**STATE OF HAWAII
DEPARTMENT OF TRANSPORTATION
HIGHWAYS**

**ADDENDUM NO. 2
FOR
KUHIO HIGHWAY RESURFACING
WAIKAEA BRIDGE TO MAILIHUNA ROAD
FEDERAL-AID PROJECT NO. NH-056-1(063)
DISTRICT OF KAWAIHAU
ISLAND OF KAUAI
April 27, 2023**

This Addendum makes the following amendments to the Bid Documents:

TYPICAL CONCRETE FOUNDATION AND TRANSFORMER BASE DETAIL
Not To Scale

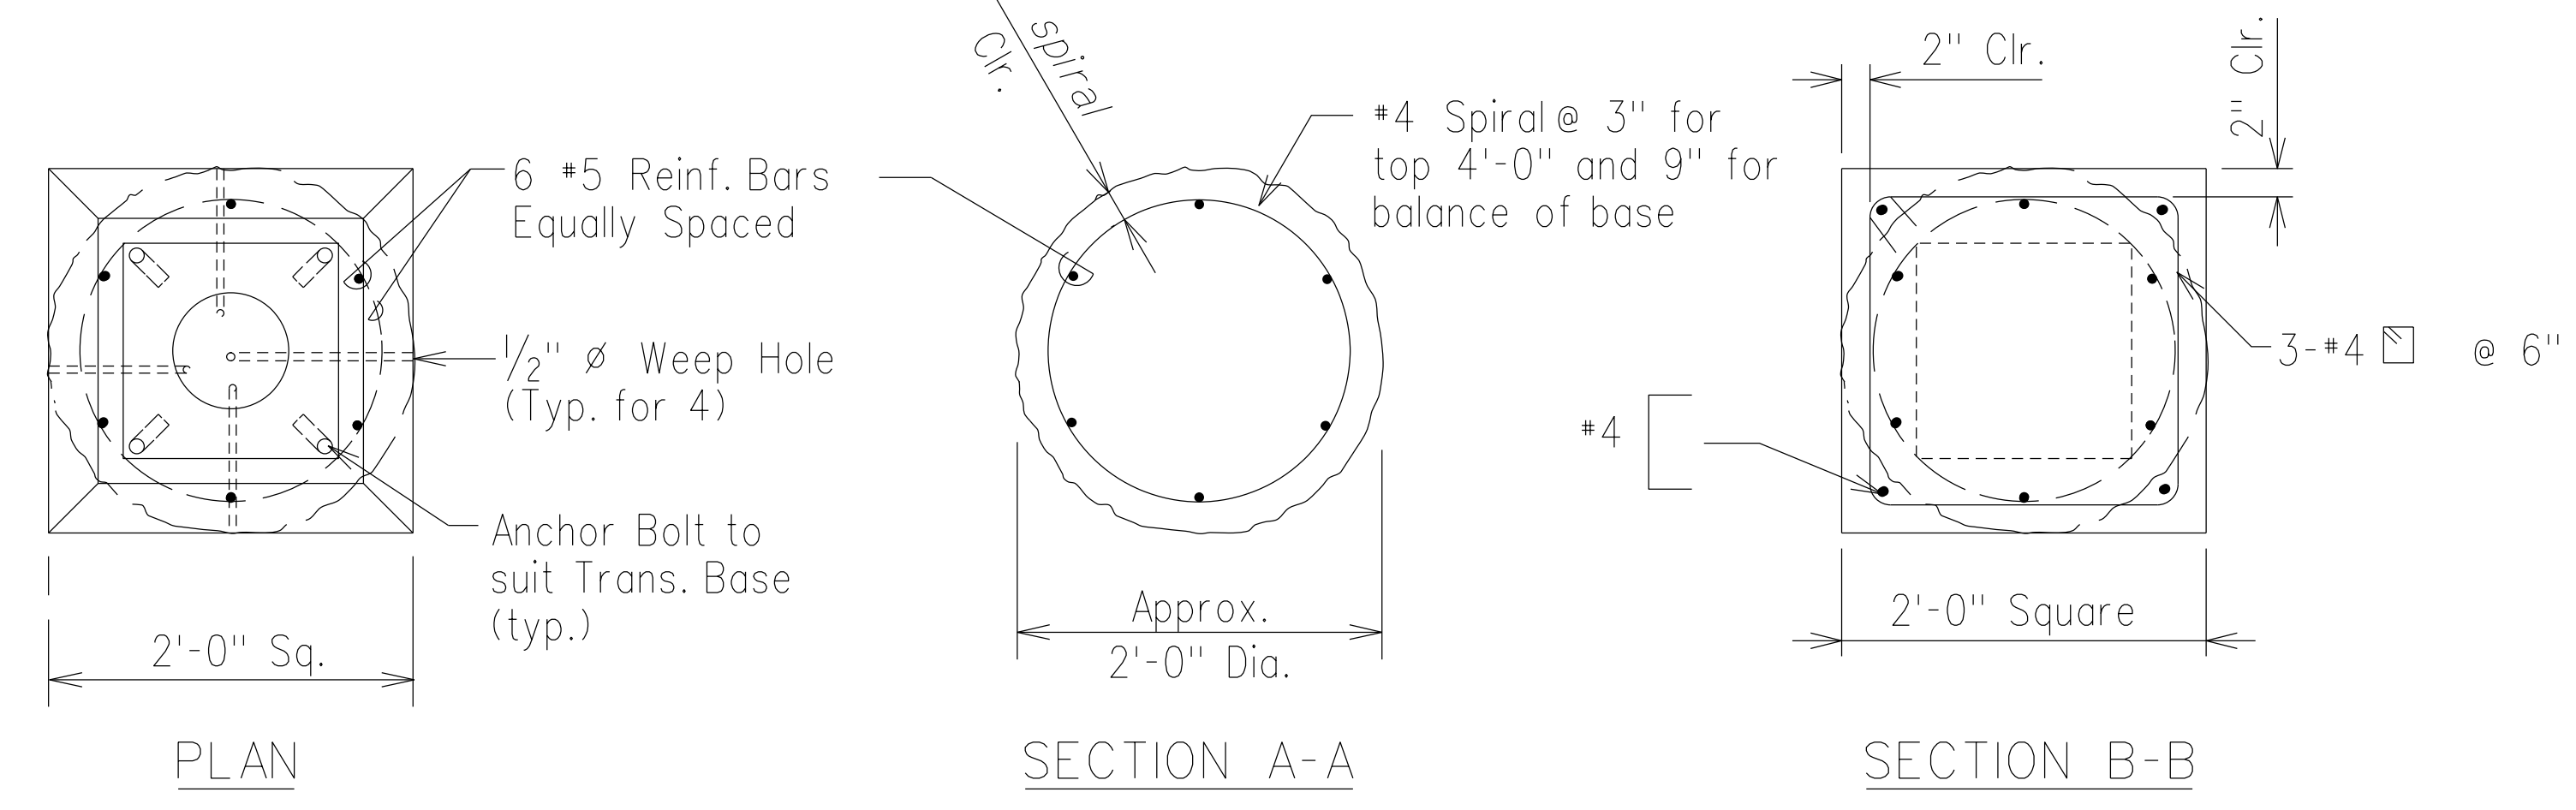
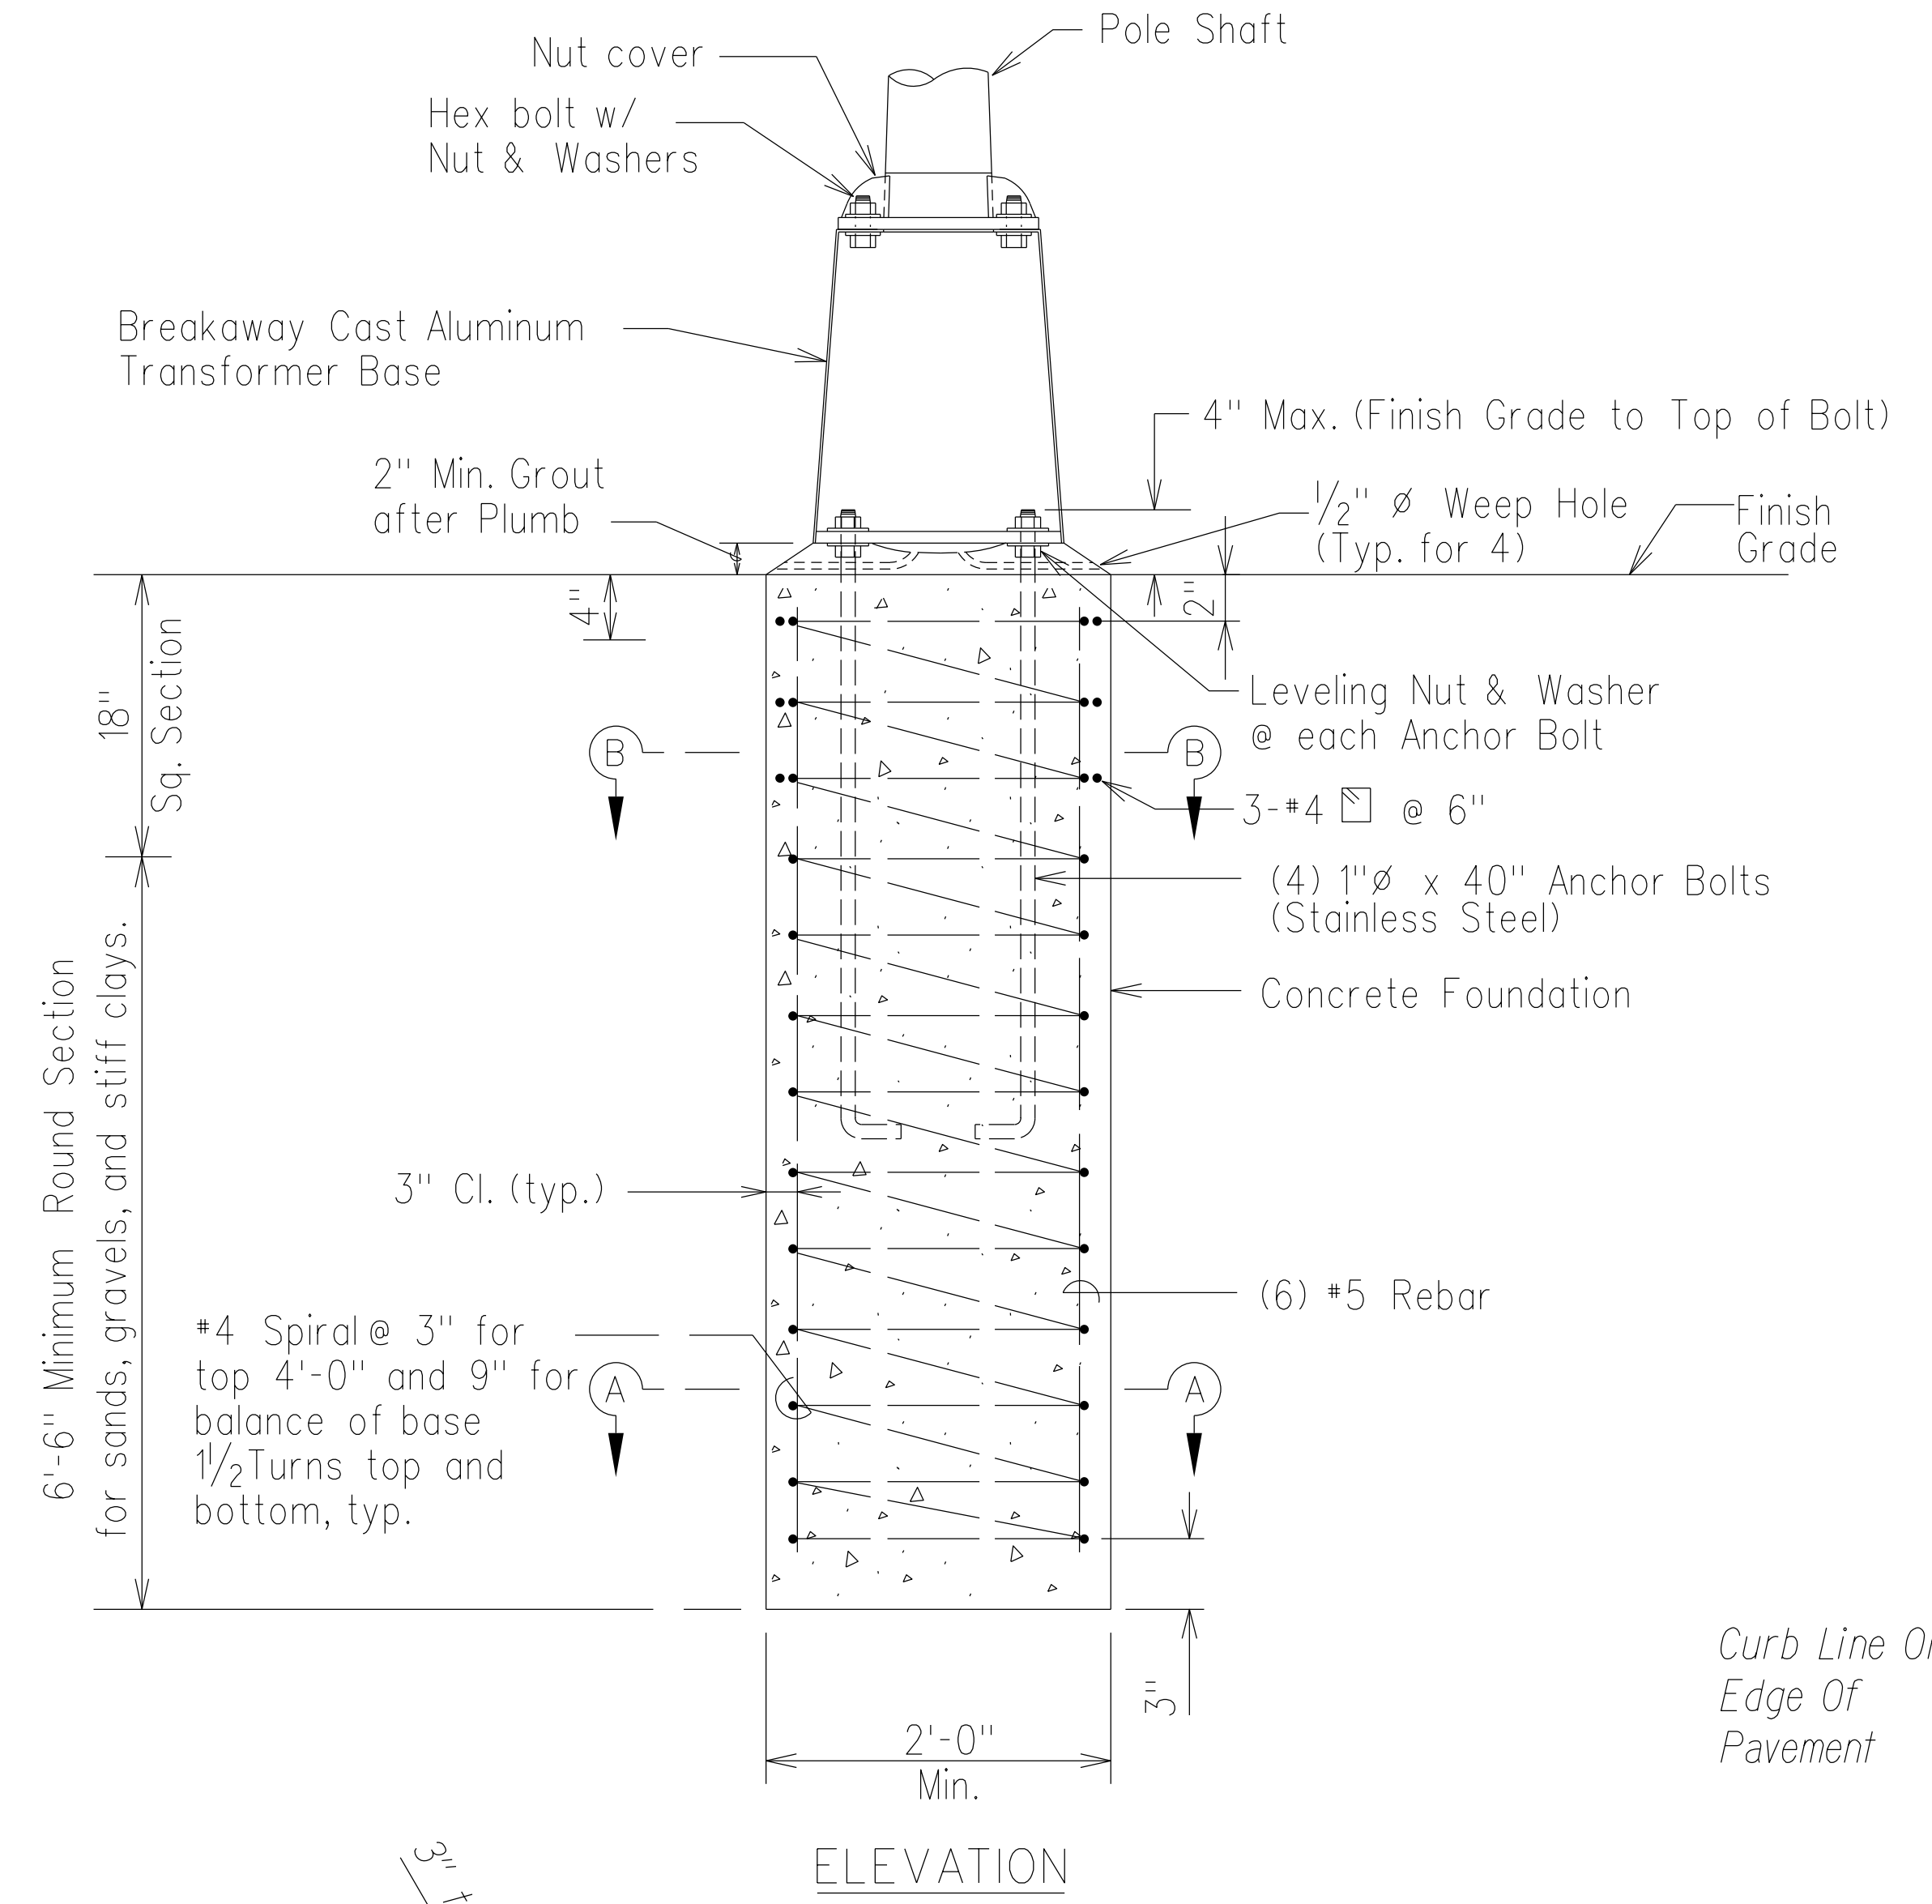
33. Is there a brand or type of break-away pedestal base that is required for the Rectangular Rapid Flashing Beacon? Can a detail of the break-away base be provided?

RESPONSE: See addendum 2 for added detail.
